Memo:

Subject: Review of NUREG-2115 Earthquake catalog with regard to identification of additional Reservoir Induced Seismicity (RIS) earthquakes in the southeastern United States and locations of earthquakes in South Carolina near the time of the 1886 Charleston, SC earthquake sequence.

Robert Youngs  
AMEC Environment & Infrastructure

## VC Summer

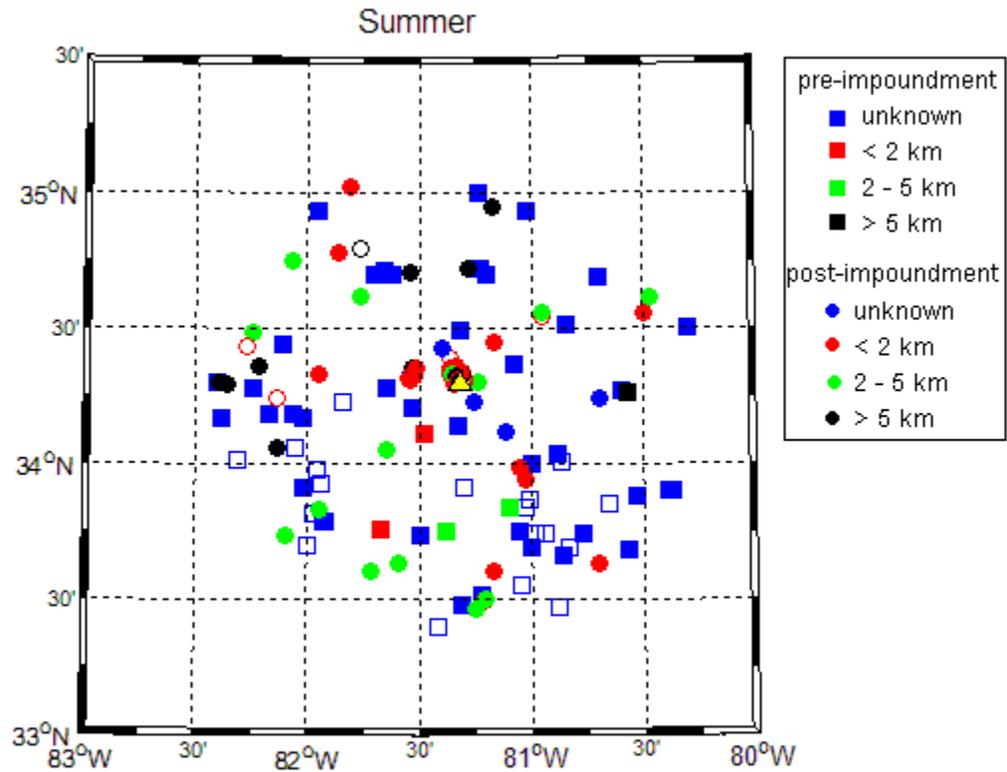
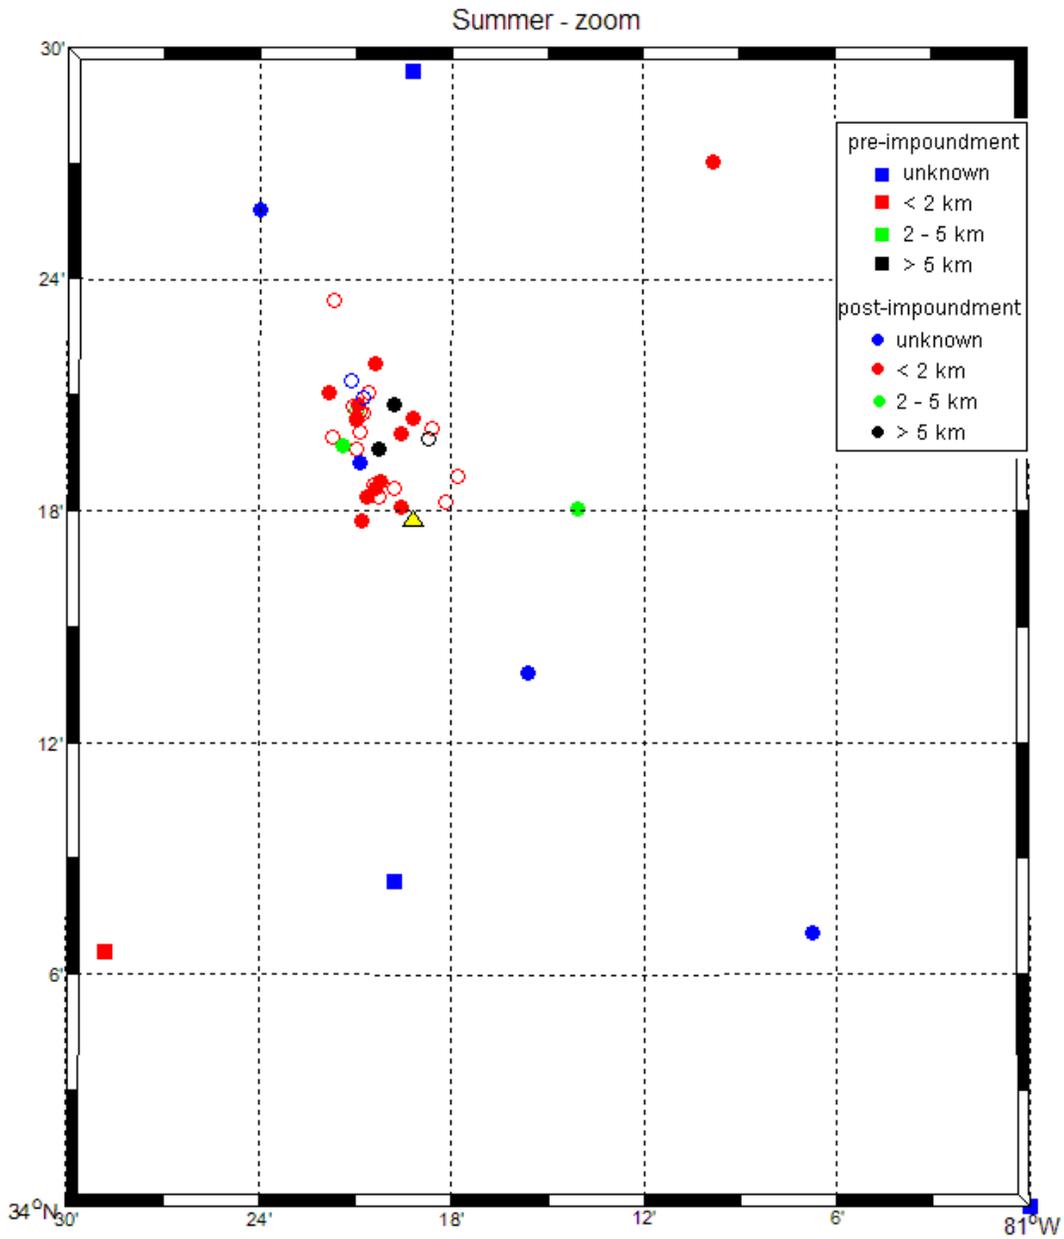
There are 262 earthquakes within 100 km of the VC Summer NPP. The seismicity pre-1968 has unknown depth (fixed at 0). There is a cluster of seismicity very near the NPP, which is associated with the Monticello Reservoir.

The enlarged figure above shows this cluster in detail: there are two clusters of earthquakes. One cluster is closer to the NPP (earthquakes have mostly depths of 1 km), and one cluster is further to the north where there are events in the 2-5 km depth range. The figure also shows that most of the earthquakes are removed in the declustering process. The next figure compares the seismicity near the VC Summer NPP to figure 2 of [12] that shows the seismicity in from 15 December 1996 to 31 December 1999.

Isoseismal map for January 19, 1860 earthquake provided by Donald Stevenson and Predeep Talwani (written communication, February 19, 2014).

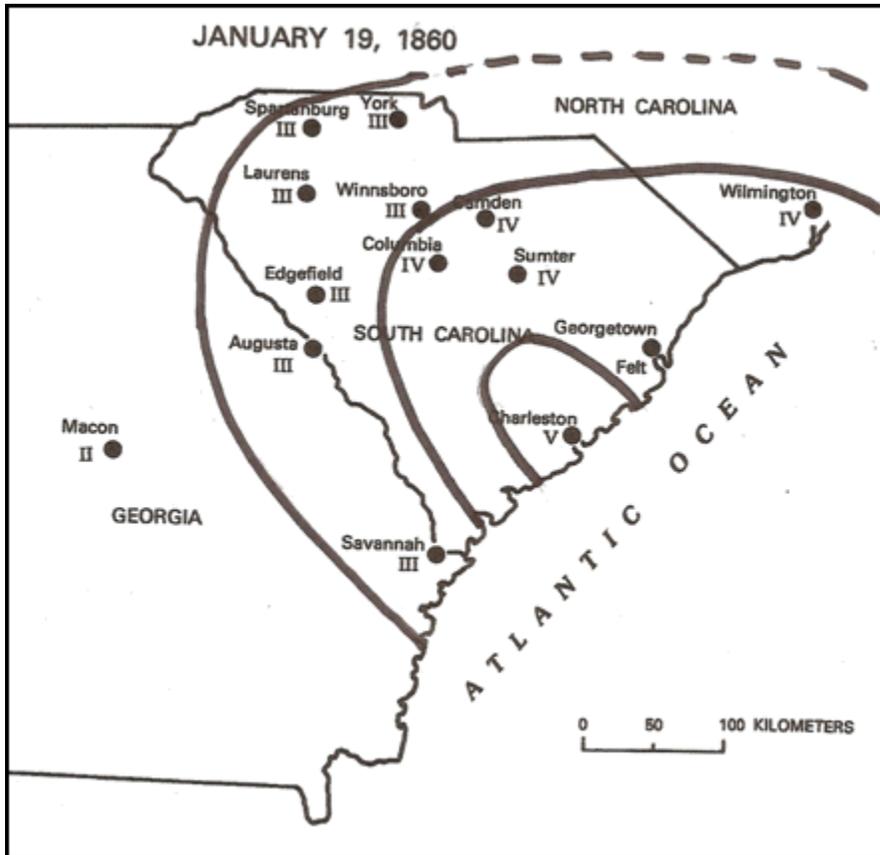
The location in the Version 7 catalog is based on NCEER-91. Donald Stevenson and Dr. Predeep Talwani provided the Isoseismal map shown below based on their interpretation of the available intensity data. These data clearly suggest a location near Charleston. The recommendation is to utilize the Charleston location given in the SUSN catalog.

Figure A1 comparison of  $\ln(\text{FA})-I_0$  data for Category 3 Earthquakes from Seeber and Armbruster (1987) with data from other earthquakes from the CEUS SSC Version 7 catalog.

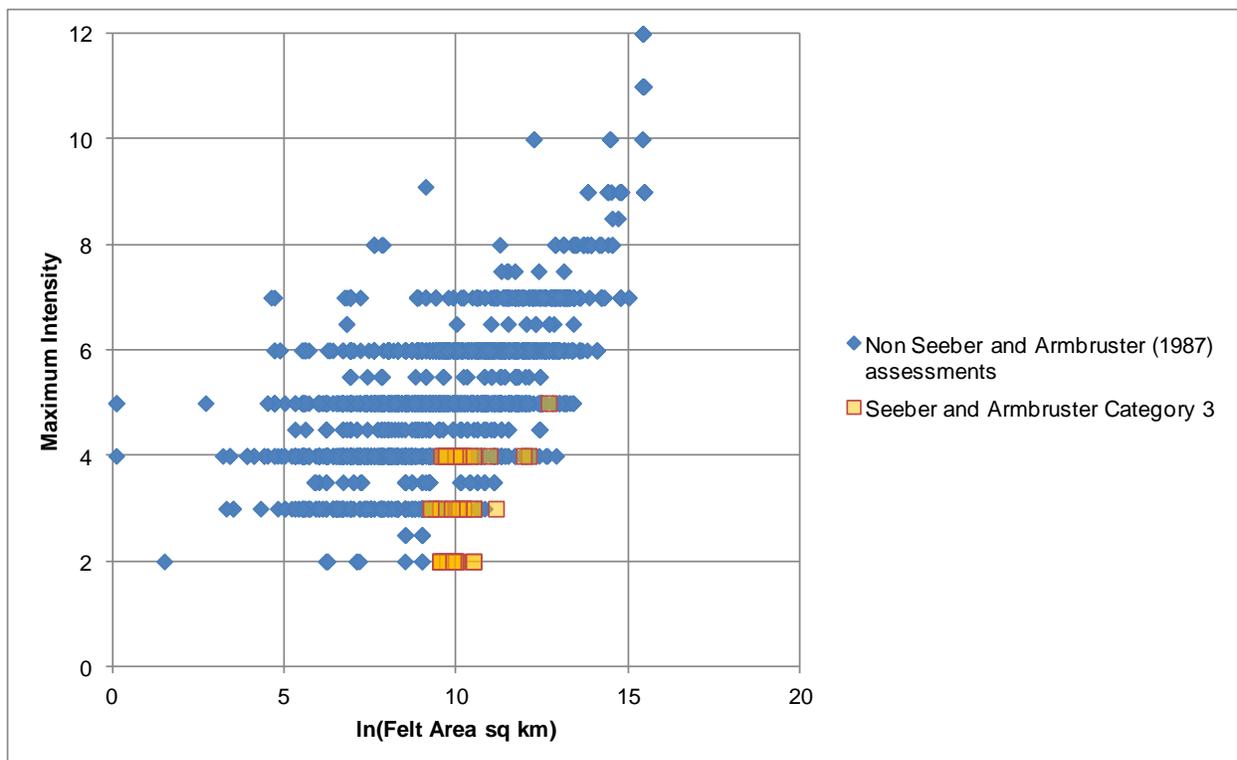
The description of Category 3 events as “unreliable” and having large areas without felt reports between towns with felt reports indicates that the assigned felt areas for these events may also be unreliable. In many cases, the maximum intensity for Category 3 events is II or III. Figures A1, A2, A2, and A3 compare the I0 and ln(FA) values for Category 3, 4, and 5 earthquakes, respectively from Seeber and Armbruster (1987) with the data from other earthquakes in the Version 3 CEUS SSC catalog. The values of ln(FA) for Category 3 appear to be biased high for the assigned I0 compared to the general population. Given the evident bias and the unreliability of the events, the Seeber and Armbruster Category 3 events that are duplicated by SUSN

events are removed from the Version 8 catalog and for those Category 3 events that are not duplicated, the values of  $\ln(\text{FA})$  are removed from the Version 8 listing for use in magnitude assessment.

Figure A2 comparison of  $\ln(\text{FA})-I_0$  data for Category 4 Earthquakes from Seeber and Armbruster (1987) with data from other earthquakes from the CEUS SSC Version 7 catalog.

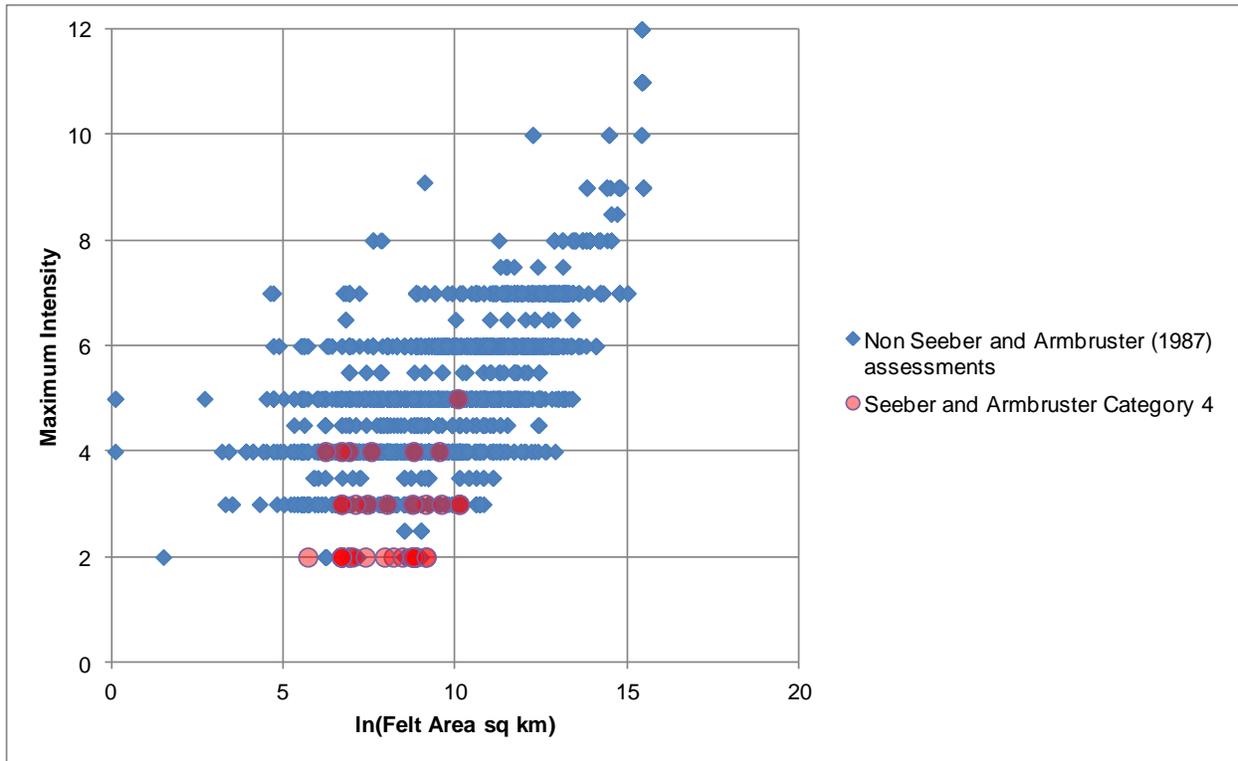
The comparisons for the Category 4 earthquakes on Figure A2 show general consistency in the  $I_0$ - $\ln(\text{FA})$  data with the rest of the catalog. Many of the Category 4 earthquakes have locations near Charleston. These events are left in the catalog.

This is a Category 4 earthquake in Seeber and Armbruster (1987) and is listed in NCEER-91. Its  $I_0$  (3) and  $\ln[\text{FA}]$  (8.0) are consistent with the general population of CEUS SSC earthquakes (see Figure A2). However, Stevenson and Talwani (written communication, 2014) state:

Although this event was listed as a category 4 earthquake in Seeber and Armbruster (1987), it was not carried forward into NCEER-91. Also the  $\ln(\text{FA})$  of 8.46 is anomalous compared to the  $I_0$  of II (Figure A2). The recommendation is to not use the felt area reported by Seeber and Armbruster (1987), which will result in the event not being considered in estimation of earthquake recurrence.

Although this event was listed as a category 4 earthquake in Seeber and Armbruster (1987), it was not carried forward into NCEER-91. Also the  $\ln(\text{FA})$  of 8.92 is anomalous compared to the  $I_0$  of II (Figure A2). The recommendation is to not use the felt area reported by Seeber and Armbruster (1987), which will result in the event not being considered in estimation of earthquake recurrence.

This is a Category 4 earthquake in Seeber and Armbruster (1987) and is listed in NCEER-91. Its  $I_0$  (3) and  $\ln[FA]$  (7.09) are consistent with the general population of CEUS SSC earthquakes (see Figure A2). Stevenson and Talwani (written communication, Feb 26, 2014) indicate:

This is a Category 4 earthquake in Seeber and Armbruster (1987) and is listed in NCEER-91. Its  $I_0$  (4) and  $I_n[FA]$  (7.55) are consistent with the general population of CEUS SSC earthquakes (see Figure A2). Stevenson and Talwani (written communication, Feb 26, 2014) indicate:

Figure A3 comparison of  $\ln(\text{FA})$ - $I_0$  data for Category 5 Earthquakes from Seeber and Armbruster (1987) with data from other earthquakes from the CEUS SSC Version 7 catalog.

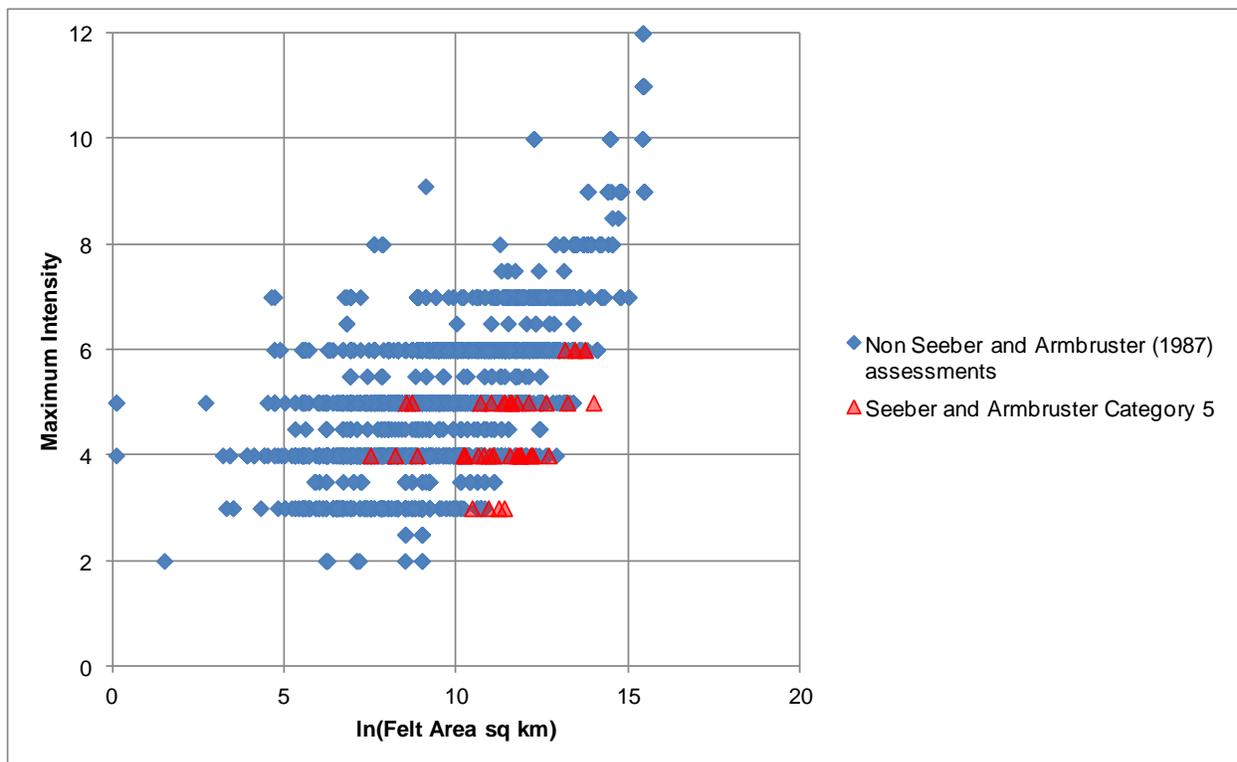
This is a Category 5 earthquake in Seeber and Armbruster (1987) and is listed in NCEER-91. Its  $I_0$  (4) and  $\ln(\text{FA})$  (8.22) are consistent with the general population of CEUS SSC earthquakes (see Figure A3). Stevenson and Talwani (written communication, Feb 26, 2014) indicate:
